# UNITED STATES PATENT AND TRADEMARK OFFICE

APPLICATION NO.	FILING DATE	FIRST NAMED INVENTOR	ATTORNEY DOCKET NO.	CONFIRMATION NO.
10/792,337	03/03/2004	Scott Steffensmeier	2602.68249	4552
48844	7590	02/07/2006	EXAMINER	
GREER, BURNS & CRAIN, LTD. ATTN: JAMES K. FOLKER 300 SOUTH WACKER DRIVE SUITE 2500 CHICAGO, IL 60606			SWIGER III, JAMES L	
		ART UNIT	PAPER NUMBER	
		3733		
DATE MAILED: 02/07/2006

<b>Office Action Summary</b>	Application No.	Applicant(s)
	10/792,337	STEFFENSMEIER ET AL.
	Examiner James L. Swiger	Art Unit 3733
<p>-- The MAILING DATE of this communication appears on the cover sheet with the correspondence address --</p> <p><b>Period for Reply</b></p> <p>A SHORTENED STATUTORY PERIOD FOR REPLY IS SET TO EXPIRE 3 MONTH(S) OR THIRTY (30) DAYS, WHICHEVER IS LONGER, FROM THE MAILING DATE OF THIS COMMUNICATION.</p> <ul style="list-style-type: none"> <li>- Extensions of time may be available under the provisions of 37 CFR 1.136(a). In no event, however, may a reply be timely filed after SIX (6) MONTHS from the mailing date of this communication.</li> <li>- If NO period for reply is specified above, the maximum statutory period will apply and will expire SIX (6) MONTHS fro

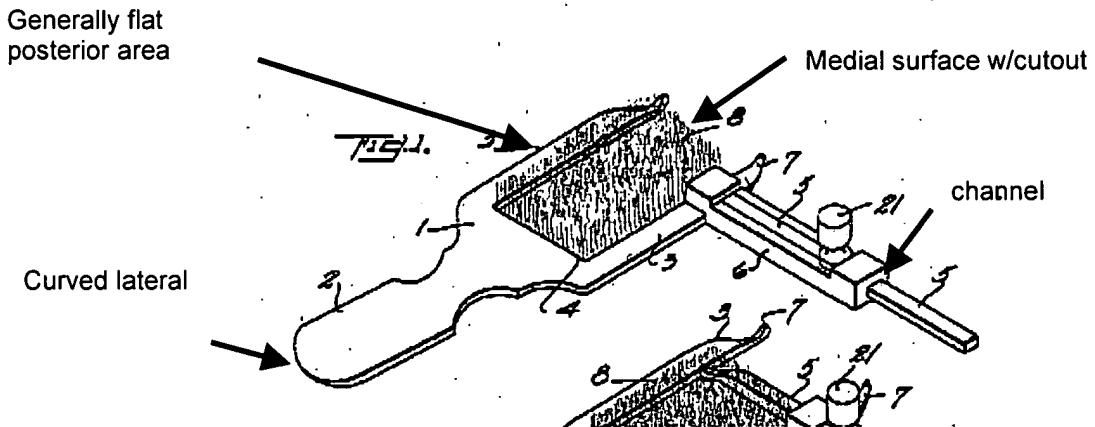
Claims 1-5 are rejected under 35 U.S.C. 102(b) as being anticipated by Nessler (U.S. Patent No. 1,962,518). With regard the statement of intended use pertaining to claims 1-5 and other functional statements, they do not impose any structural limitations on the claims distinguishable over Nessler, which is capable of being used as claimed if one so desires to do so. *In re Casey*, 152 USPQ 235 (CCPA 1967) and *In re Otto*, 136 USPQ 458, 459 (CCPA 1963). Furthermore, the law of anticipation does not require that the reference "teach" what the subject patent teaches, but rather it is only necessary that the claims under attack "read on" something in the reference. *Kalman v. Kimberly Clark Corp.*, 218 USPQ 781 (CCPA 1983). Furthermore, the manner in which a device is intended to be employed does not differentiate the claimed apparatus from prior art apparatus satisfying the claimed structural limitations. *Ex parte Masham*, 2 USPQ2d 1647 (1987).

Nessler discloses a device having a head (See Fig. 1 below), a handle extending outwardly from the head (6), a channel that extends through at least a portion of the head and handle (Fig. 1), and a slider (5). Nessler also discloses a head that has

a posterior surface that is generally flat (See Fig. 1), a lateral outer surface that is curved (see Fig. 1), and a third medial surface that is generally flat (Fig. 1) and has a cutout portion. Nessler also discloses a hook at the end of the slider (7) capable of making contact with the posterior portion of a proximal tibia, which is cited functionally.

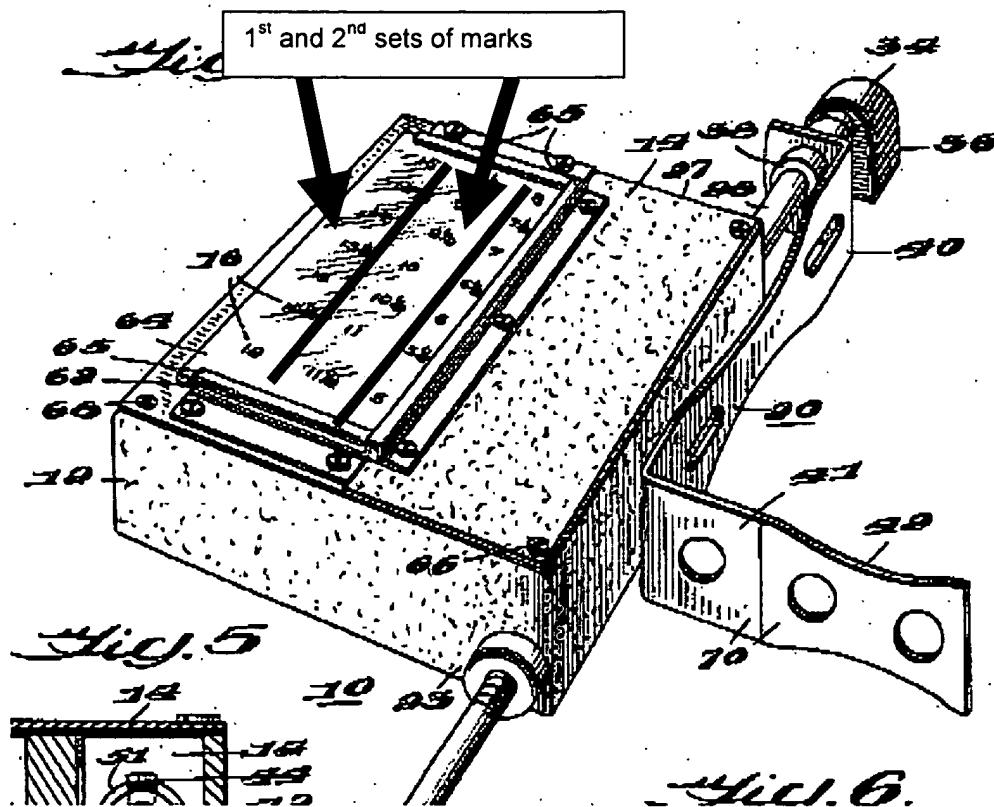
Claims 1 and 7-9, and 12 are rejected under 35 U.S.C. 103(a) as being unpatentable over Smith (U.S. Patent No. 2,530,477) in view of Peabody et al. (U.S. Patent No. 6,979,299).

Smith discloses a device having a head (12), a handle extending outwardly from the said head (42), and a channel (32 and see Fig. 2), and a slider (22) configured to be slidably positioned within the channel. Smith also discloses a device that has a first and second set of markings (Fig. 1b drawn below).

Smith discloses the claimed device except for a slider that includes markings and that can be used independently. Peabody et al. Discloses a measuring guide with a slider that has markings (22), is capable of use with the device of Smith to provide a third set of markings (46), where the markings are not visible when used in the channel of the device of Smith, but are visible when used without the handle of Smith, essentially as a ruler. The modifications of Peabody et al. including the slider with markings and the slider's separate use as a ruler-type device are to facilitate the marking and measuring of the tibial bone in use (See abstract of Peabody et al., Front page). It would have been obvious to one having ordinary skill in the art at the time the invention was made to construct the device of Smith having at least a slider having
